## Process Sheet

Customer : CU-DAR001 Dart Helicopters Services  
 Job Number : 32720-2  
 Estimate Number : 12577  
 P.O. Number : N/A  
 This Issue : 5/31/2007 S.O. No. : N/A  
 Prsht Rev. : NC  
 First Issue : N/A Type : LARGE FAB ASSY  
 Previous Run : 31445  
 Written By :  
 Checked & Approved By : JA 07.05.31  
 Comment : Est Rev: A New Issue 06-11-09 JLM

Drawing Name : STEP WELDMENT  
 Part Number : D3562042  
 Drawing Number : D3562 UNDER REVIEW  
 Project Number : N/A  
 Drawing Revision : A  
 Material : N/A  
 Due Date : 6/11/2007

DESIGN	q	DRAWN BY	q	DART AEROSPACE LTD HAMKESBURG, ONTARIO, CANADA
CHECKED	h	APPROVED	h	REV. B
DATE	07.01.15	TITLE	D3562	SHEET 1 OF 1
		STEP ASSEMBLY		SCALE
		NEW ISSUE		NTS
		ARMS NOW RIVETED TO STEP

**TYPICAL STEP END DETAIL**  
NOT TO SCALE

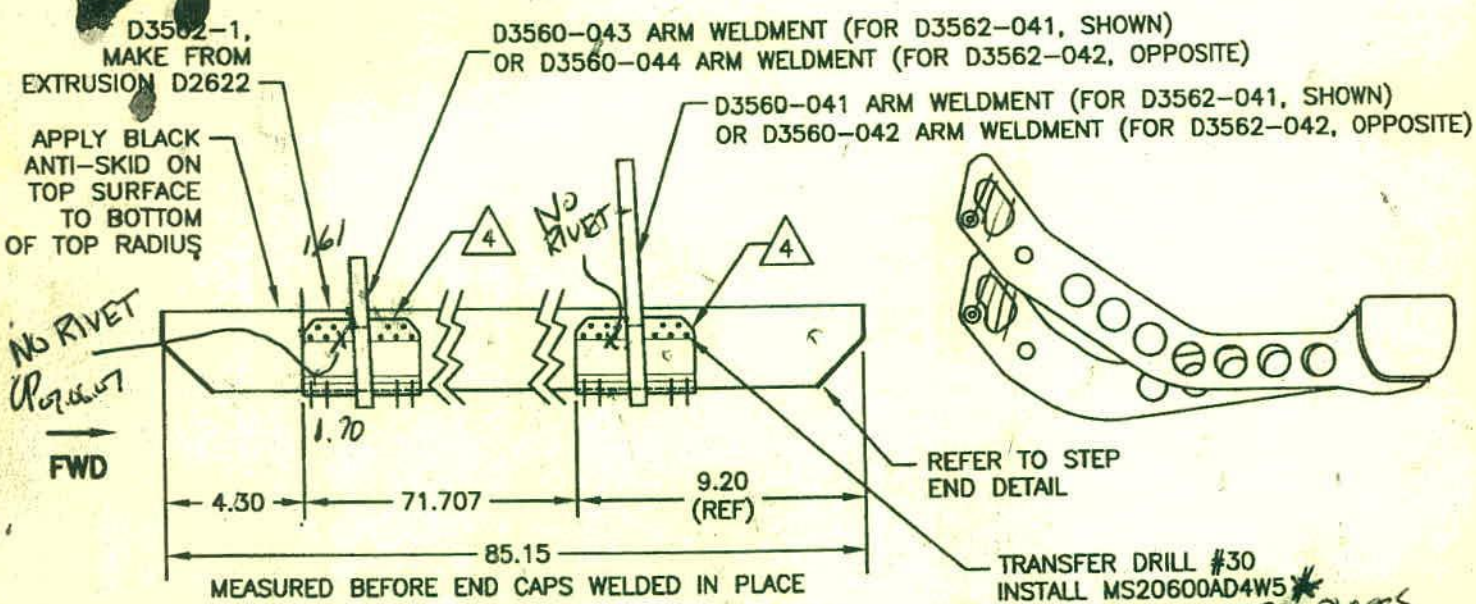
TRANSFER DRILL #30  
INSTALL MS20600AD4W5\*  
RIVET (36 PLACES)  
DEBURR & TOUCH UP HOLES  
WITH CHEMICAL CONVERSION  
COAT BEFORE RIVETING,  
TOUCH-UP RIVET HEADS  
WITH PAINT PER  
DART QSI 005 4.2

MAGNABOND  
07.06.07  
REF DS  
EMAIL

For the D3562-041/-042 Step Assembly, we need to remove qty(1) rivet from each D3560-XX Arm weldments attachments for manufacturability. There will be a total qty(34) MS20600AD4 rivets instead of qty(36) per step. The rivet will be removed from the side surface of the step. Remaining shear would be 350 lbs x 16 rivets = 5600 lbs per arm attachments.

For the D3562-041/-042 step weldment, when doing the actual assembly, it was discovered that the rivets on either side of the arm cannot be installed because of problems fitting the rivet tool. Total number of rivets will not be 32 per step assembly (was 36).

A picture is attaching which shows which 4 rivets are to be removed. Is this acceptable.

Acceptable deviation.

NO. 32720  
WORK ORDER  
UNCONTROLLED COPY  
SUBJECT TO AMENDMENT  
WITHOUT NOTICE  
SHOP COPY  
RETURN TO  
ENGINEERING

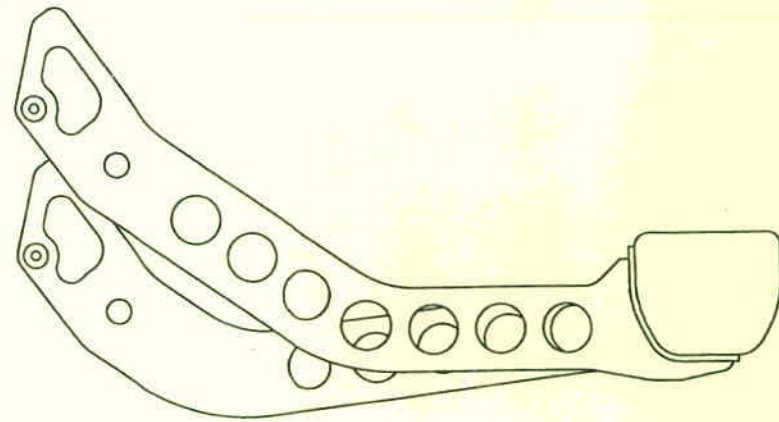
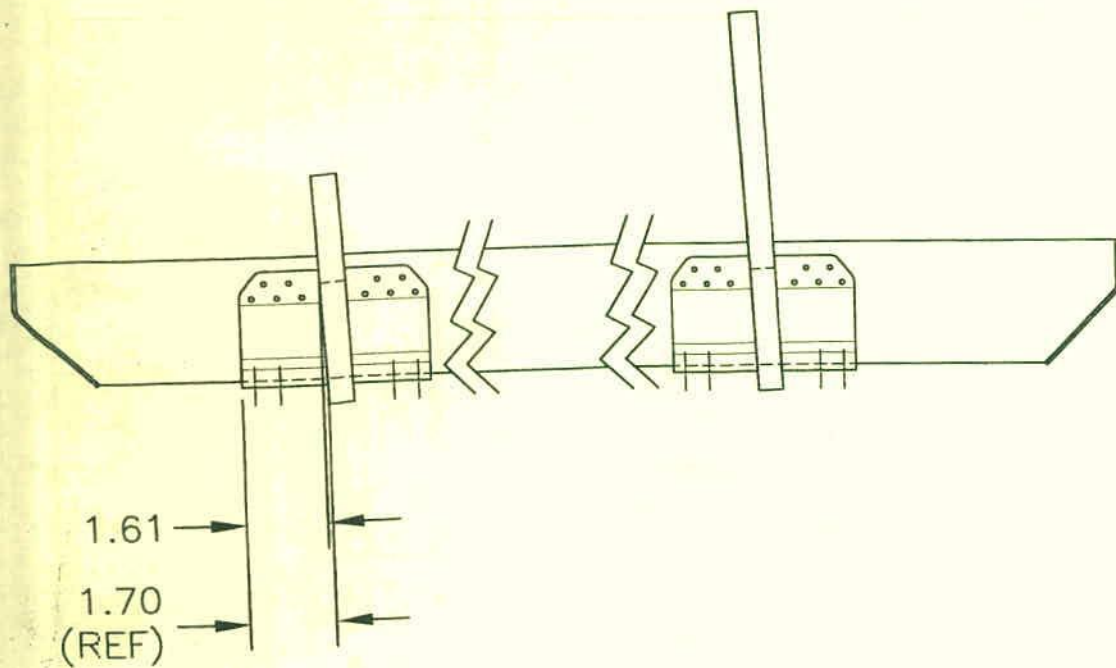
For the D3562-041/-042 step weldment, as discussed. They want to switch from Sikaflex to Magnabond, and powder coat after final assembly.

As part of this change, the D3560-XX arms won't be powder coated, and the D2808 Bushing won't be assembled until after final assembly of the step weldment.

Since this is the first time trying this, we will ensure that the steps are checked after powdercoating in case the Magnabond doesn't do anything unexpected (eg. bubbling). If we see anything suspect, we will assemble them the old way.

As we have discussed previously, this is acceptable as long as the Magnabond doesn't break down.
